Specific Site Assessment for Coal Combustion Waste Impoundment at PacifiCorp Energy, Dave Johnston Power Plant

Glenrock, Wyoming

June 2011
Project 092884

Figure 2

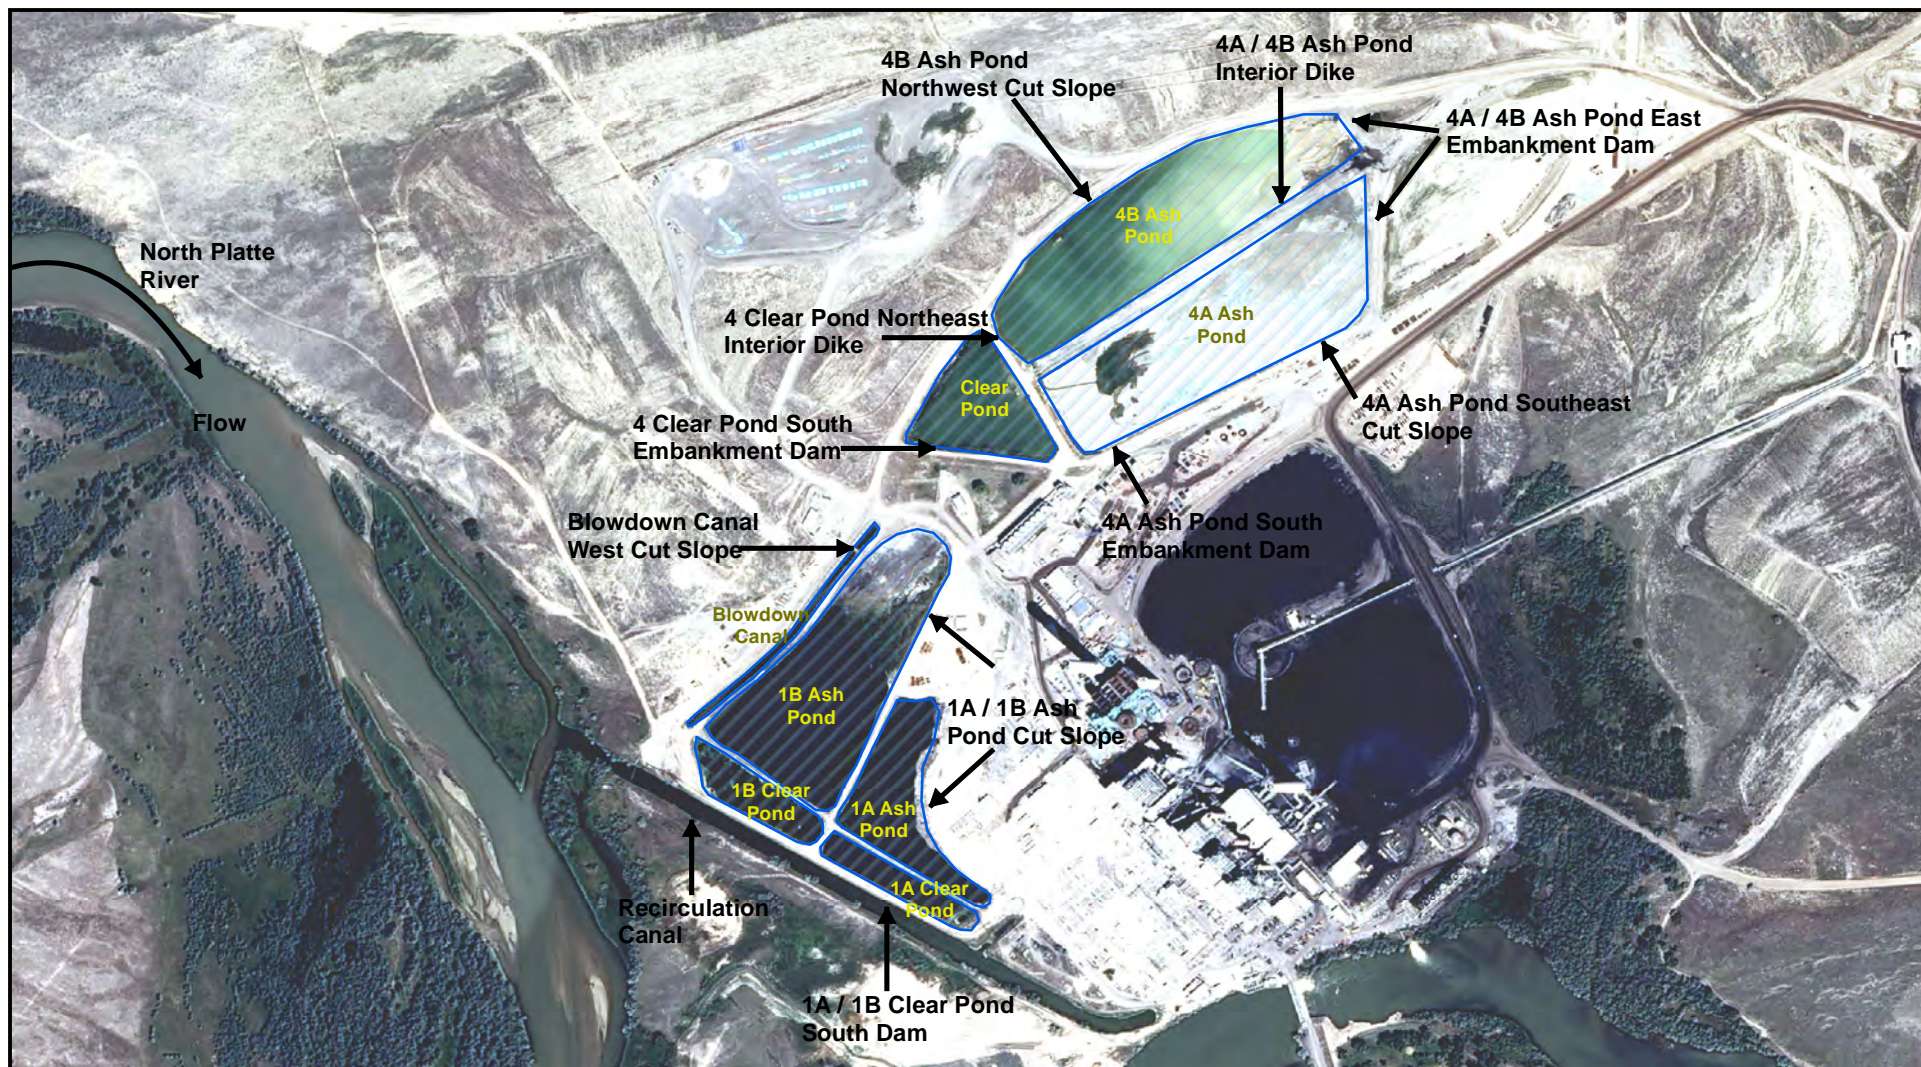
The 1A/1B Ash Ponds and Blowdown Canal are entirely subsurface and are impounded by natural cut slopes or interior divider dikes on all sides (Figure 2). Failure of one of the interior divider dikes is not likely to result in an uncontrolled release of CCW to the environment, and as such, the 1A/1B Ash Pond and Blowdown Canal are not assigned a hazard potential rating in Section 4.0.

The 4A/4B Ash Ponds were constructed as a single pond separated by an interior dike (Figure 2). The northwest and southeast margins of the ponds were excavated into the natural ground surface. Currently, the southeast embankment height ranges from 0 feet (level adjacent ground surface) in the north, to 8-10 feet in the south. The northwest margin is cut into a hillslope. At the top of the pond cut slope there is an approximately 40-foot wide level bench used as a haul/access road. The east embankment has a height of approximately 12.5 feet above the original ground surface, a crest width of approximately 25 feet, an interior slope judged to be about 4H:1V and an exterior slope judged to be about 2.5H:1V. A design drawing from 1971 (not identified as an "as-built" drawing) indicates design crest elevations of 4962.5 feet for the perimeter embankments, and 4965 feet for the Ash Pond central interior dike. The crest widths were to be 18 feet and the side slopes were to be 4H:1V upstream and 3H:1V downstream.

The 1A/1B Ash Ponds, 1A/1B Clear Ponds, and Blowdown Canal occupy a single, large triangular shaped depression (Figure 2). The ponds are all constructed entirely below grade and there is little concern for cut slope instability. Failure of one of the interior dikes would result in an equalization of water levels in the affected ponds, but would not result in overtopping of any of the perimeter slopes or embankments. Overtopping the cut slopes to the north or east would result in minor flooding of PacifiCorp property and would be contained within a limited area. No loss of life or environmental damage is expected; property damage would be limited to PacifiCorp property. The cut slope to the west of the Blowdown Canal is higher than the east divider dike. Floodwaters entering the Blowdown Canal would first flow over the east divider dike into the 1B Ash Pond or 1B Clear Pond and would not result in a release to the environment by overtopping the west cut slope.

1. A geotechnical exploration program should be performed to classify the embankment and foundation soils of the following impoundment features (See Figure 2):
